Subject: ABWR postulated Pipe Break Dynamic Nonlinear Time History Analysis

SUBJECT: ABWR POSTULATED PIPE BREAK DYNAMIC NONLINEAR
TIME HISTORY ANALYSIS

RESPONSES TO AUDIT COMMENTS (Prepared by Henry Hwang) 4 Hwang 9/1/91

Figure 2B: Impact force at the pipe whip restraint.
($\rho_a=373,600$ lb, max impact=670,000 lb)
(Included rotated blowdown angle)

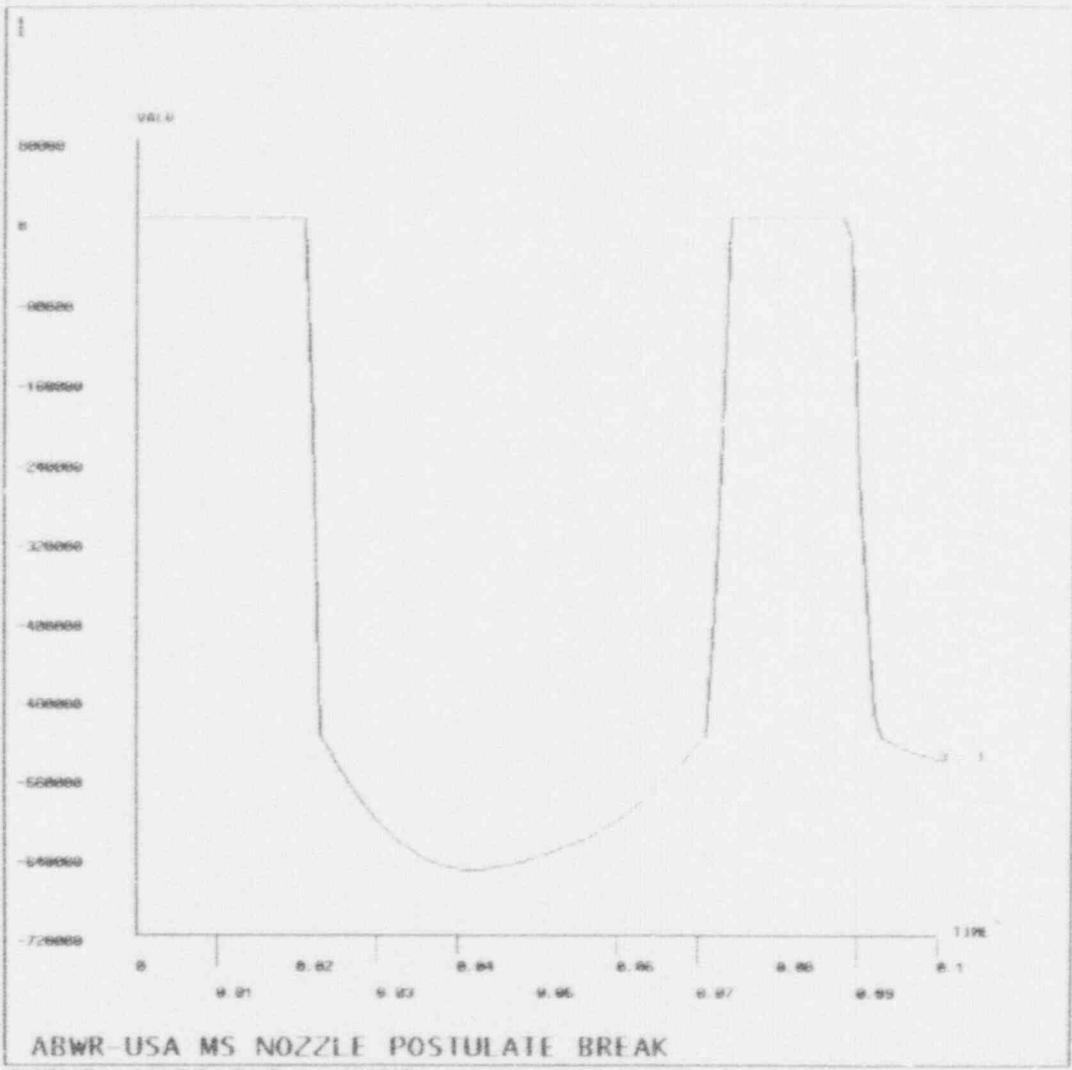
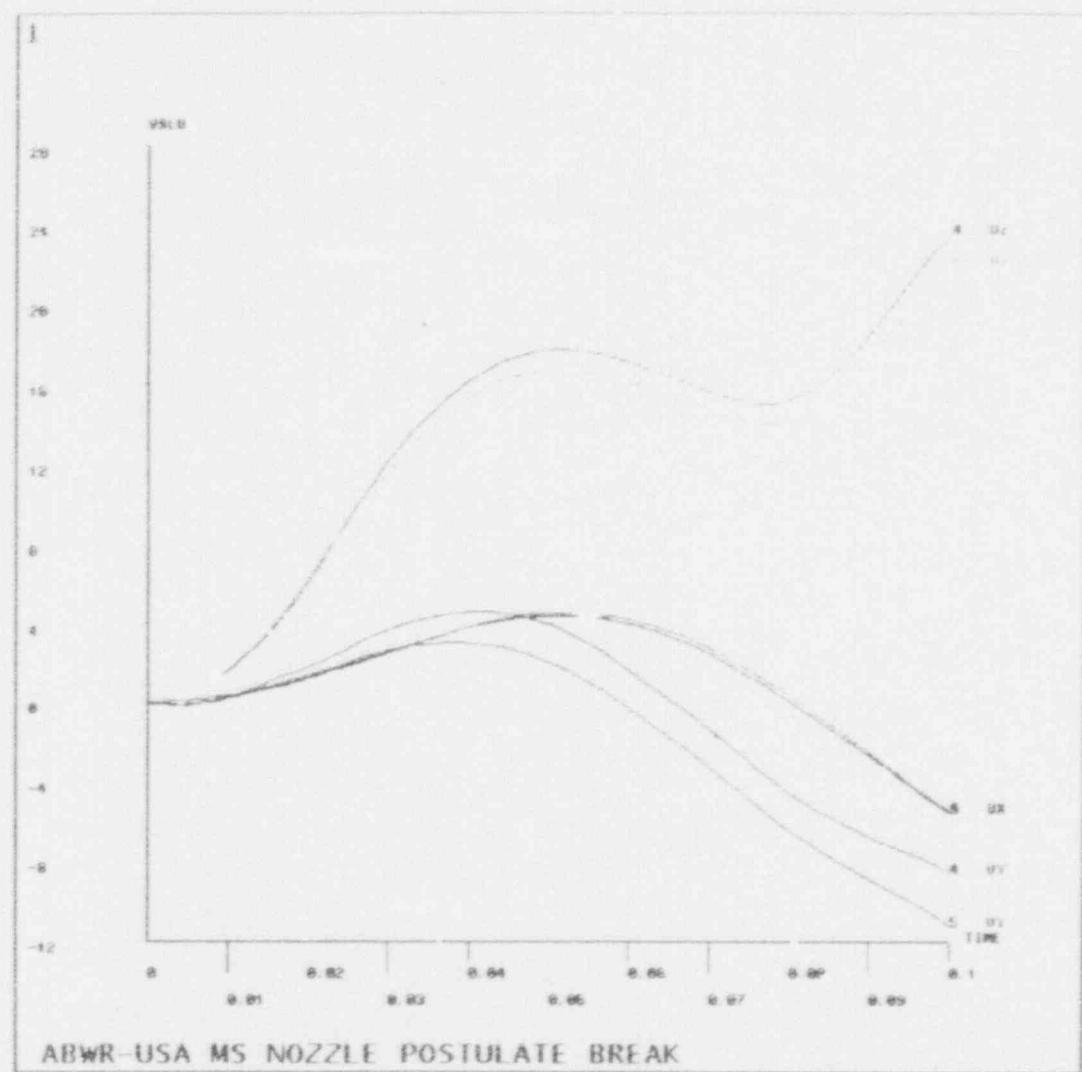
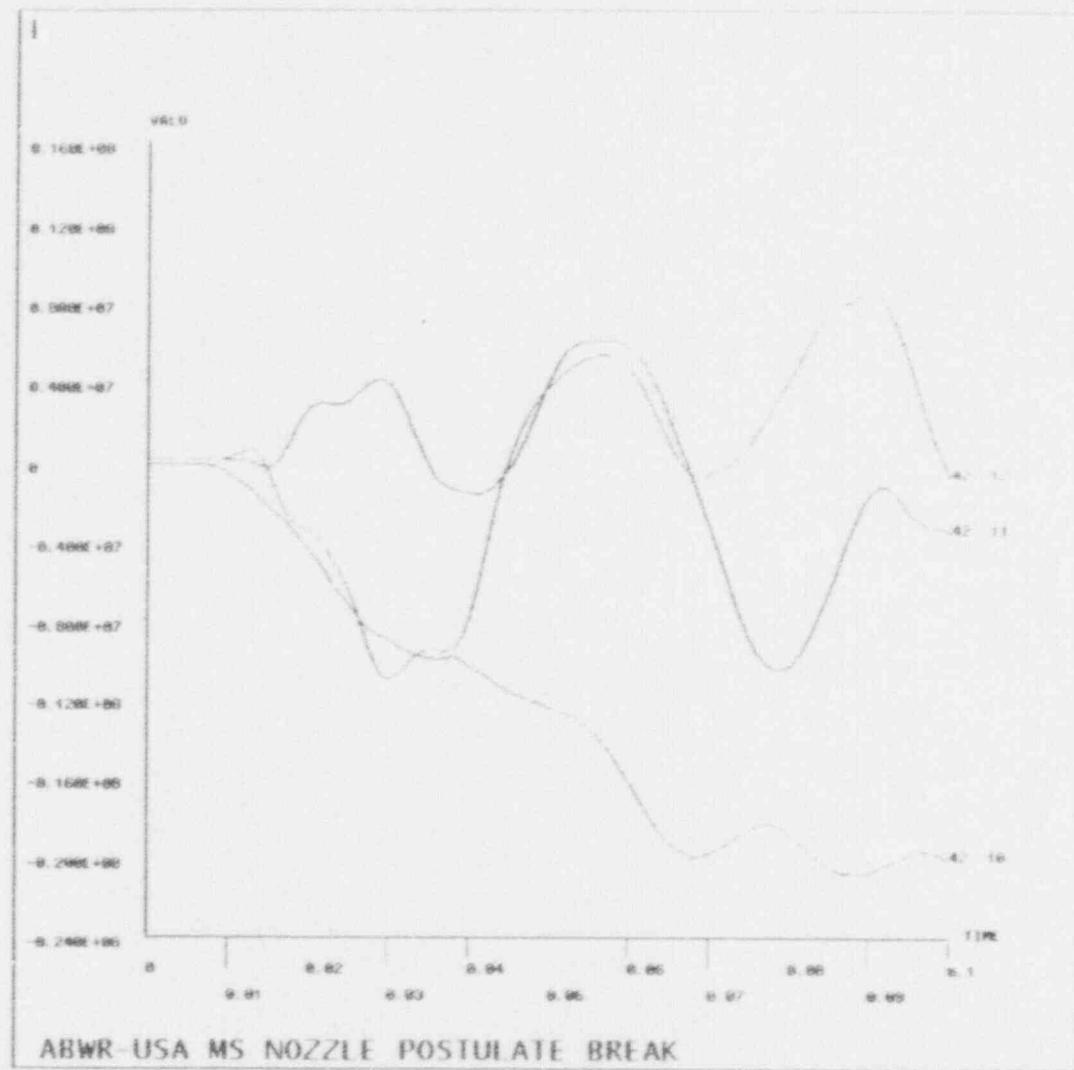
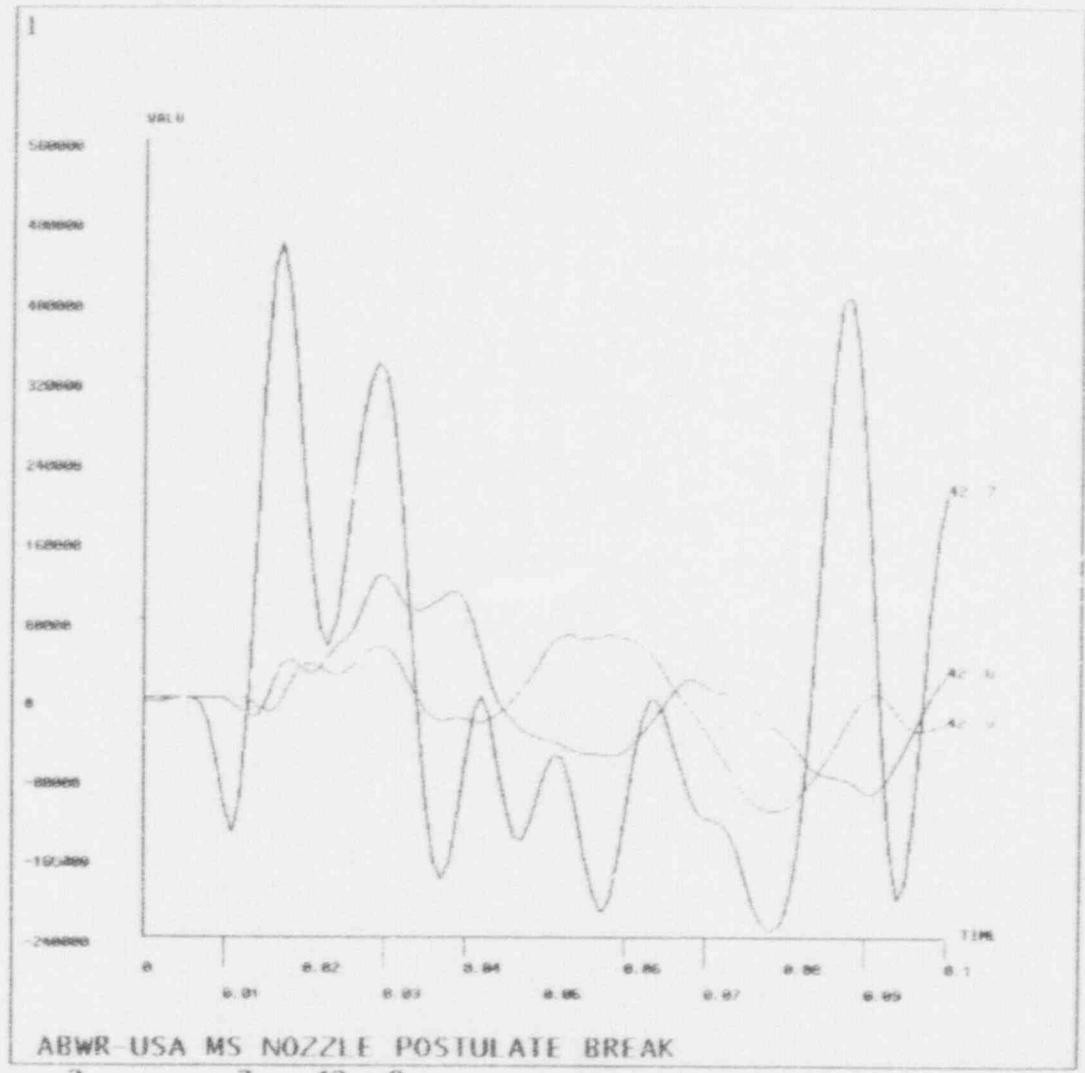
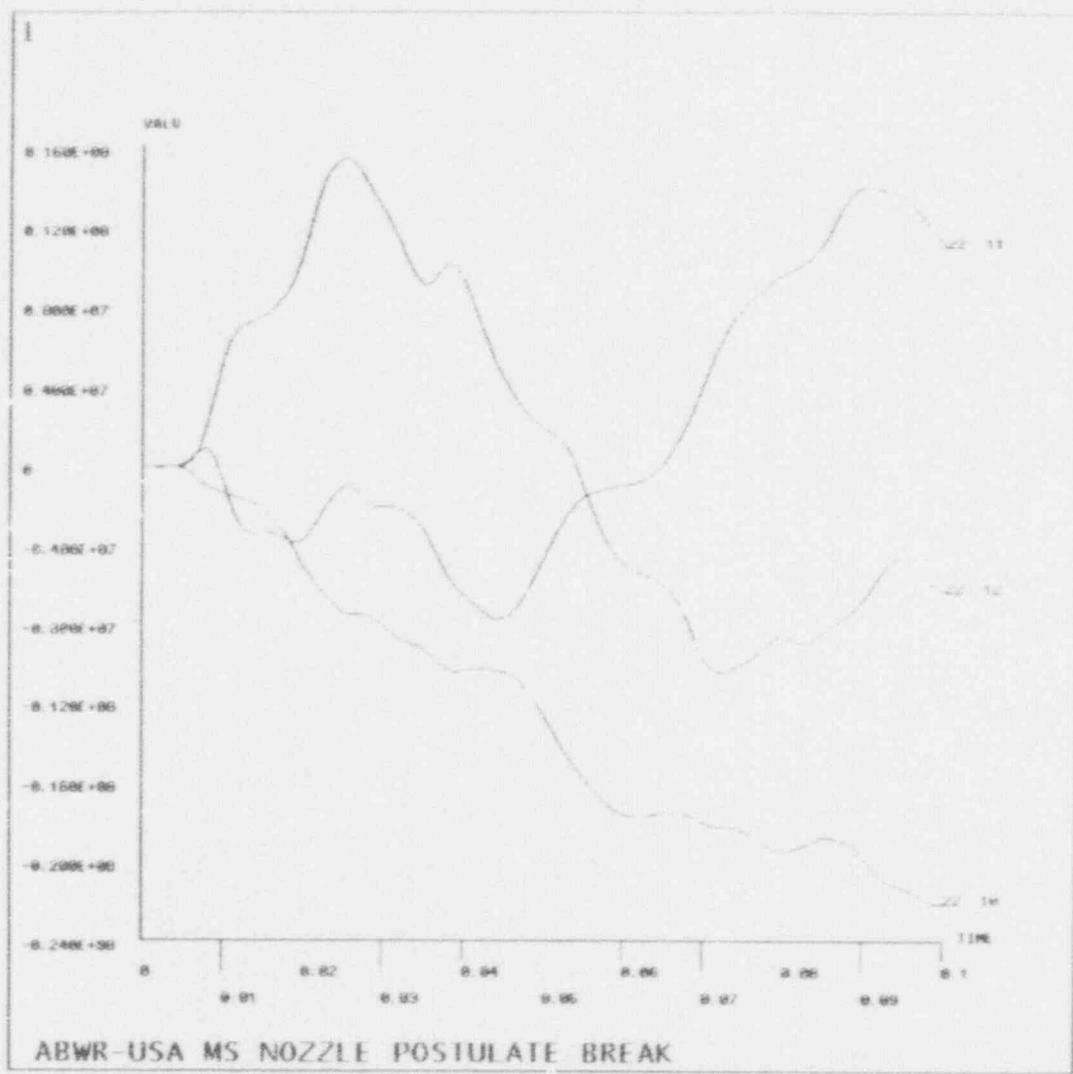
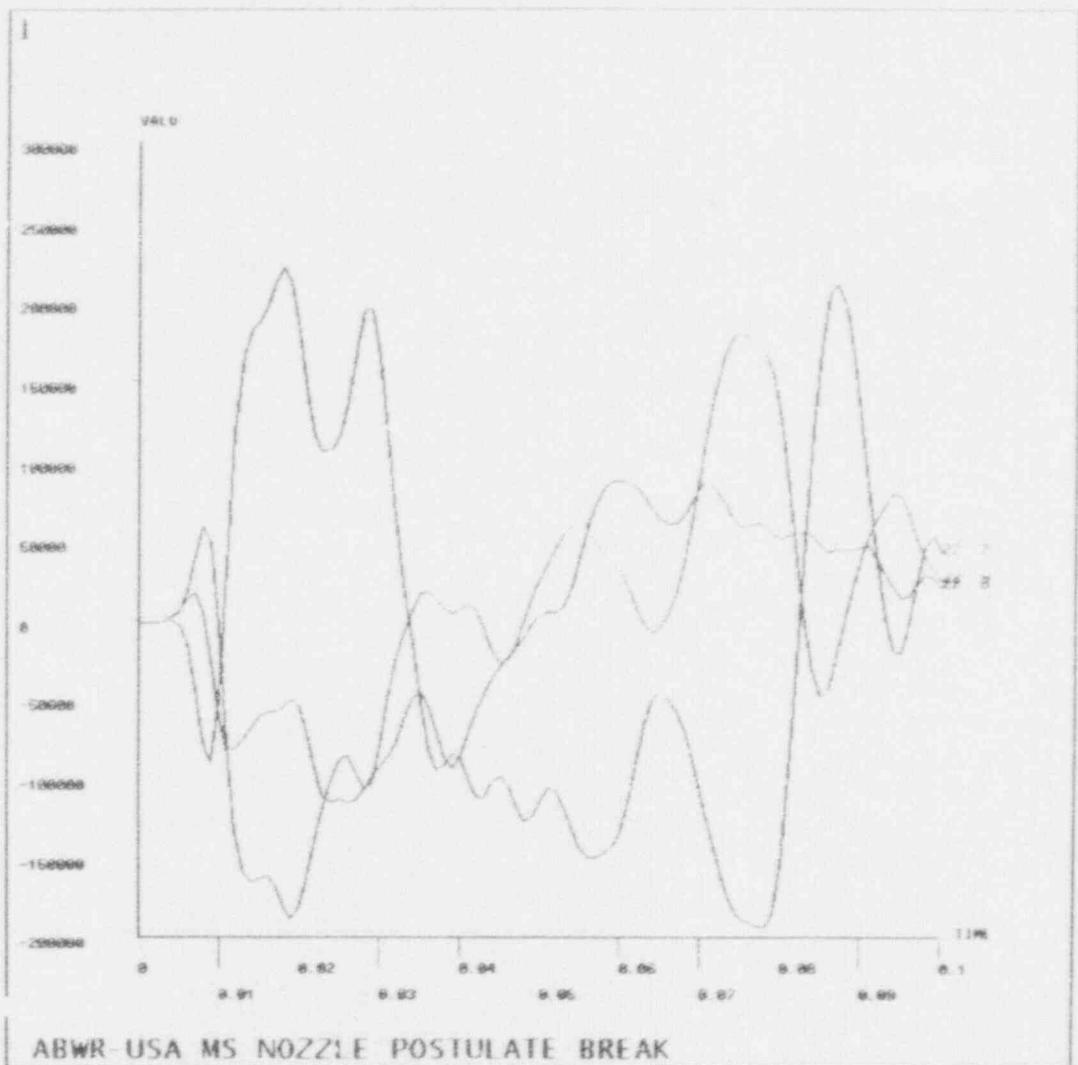
The displacements from the terminal end Main Steam Break Structure (MSBS) analysis (using ANSYS) results shows large displacements and rotation at the break. The thrust direction changes during the event which could affect the stress in the "Holy Pipe" area. Therefore, GE will use static elastic analyses for the original and displaced position to confirm the validity of the small displacement assumption in the non-linear time history analysis results.

The total blowdown force is resolved to the new direct cosine for the analysis of large displacement effect:

$$\begin{aligned} F_x &= 88,800 \text{ lb} \\ F_y &= -147,400 \text{ lb} \\ F_z &= 332,114 \text{ lb} \end{aligned}$$

The results of the analysis are shown in the figures below.

3) The rotated angle load resulted in downward thrust load will reduce the vertical displacement predicted by the analysis from the design position.

This shows that the analysis from design position is acceptable.
